**Report: DEFICIENCY REPORT**  
**Function: Test, Adjust, & Balance**  
**Date: 05/01/2025**  
**Completed By: National TAB**

**PROJECT**  
**04-28-25 CULVERS ROCKMART, GA**

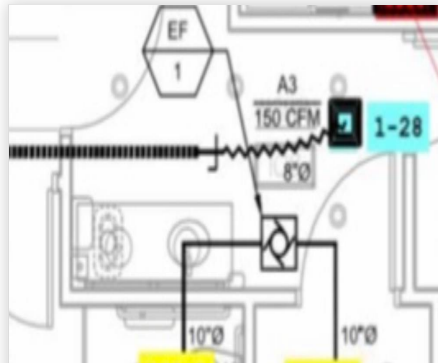
**Issue Name :** AC1 DAMPER HANDLE IS MISSING  
**Description :** The damper for the diffuser in the men's restroom is missing a damper handle.  
**Created By :** National TAB                      **Assigned To :** National TAB - Ben Searles  
**Status :** Open  
**Priority :** Urgent                                      **Asset Tag :**  
**Originated Date :** 05/01/2025 - Ben Searles - National TAB

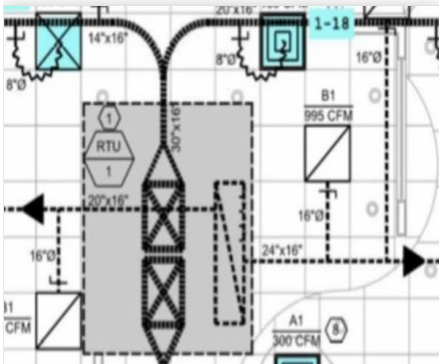
**Issue Name :** AC1 DAMPER INACCESSIBLE  
**Description :** The damper to the diffuser in the women's restroom is located above hard ceiling and is inaccessible. This is where the plans requested it to be located. The damper handle will need to be moved in order to effectively balance the diffuser.  
**Created By :** National TAB                      **Assigned To :** National TAB - Ben Searles  
**Status :** Open  
**Priority :** Urgent                                      **Asset Tag :**  
**Originated Date :** 05/01/2025 - Ben Searles - National TAB

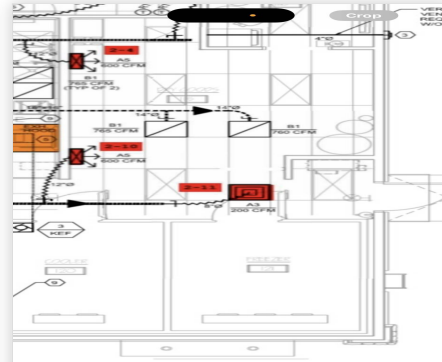
**Issue Name :** AC1 MISSING RETURN AND SUPPLY  
**Description :** AC1 is missing a return as well as supply diffuser 1-18 as depicted in the image below. Without these, the unit is unable to be properly balanced.  
**Created By :** National TAB                      **Assigned To :** National TAB - Ben Searles  
**Status :** Open  
**Priority :** Urgent                                      **Asset Tag :**  
**Originated Date :** 05/01/2025 - Ben Searles - National TAB

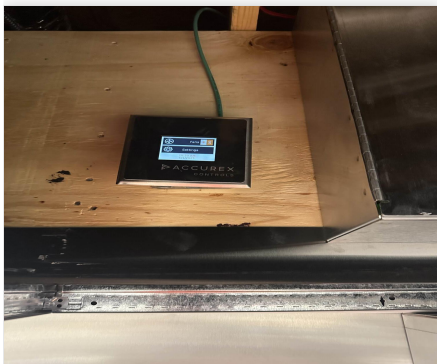
**Issue Name :** AC2 DIFFUSER IS MISSING A DAMPER  
**Description :** Diffuser 11 for AC2 is missing a damper and is unable to be balanced. The mechanical on-site reviewed the ductwork and was unable to locate the damper as well.  
**Created By :** National TAB                      **Assigned To :** National TAB - Ben Searles  
**Status :** Open  
**Priority :** Urgent                                      **Asset Tag :**  
**Originated Date :** 05/01/2025 - Ben Searles - National TAB
